SERVICE BULLETIN NO. 117

Modifications to bearing housing and pulley for CombiClean

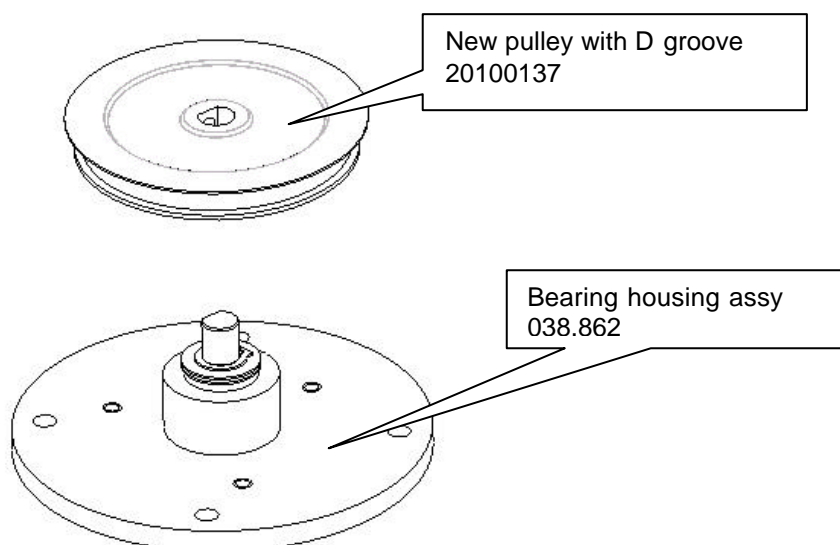
To prevent the pulley from coming loose, we have introduced a new pulley with a D groove so that even if the hexagon socket set screw comes loose, the pulley will not be able to turn.

As the pulley now has a D track and the contact face of the driving plate pin has become larger, the new parts cannot be used together with old parts. Consequently, a modification kit, part No 20120200, for older ovens is available.
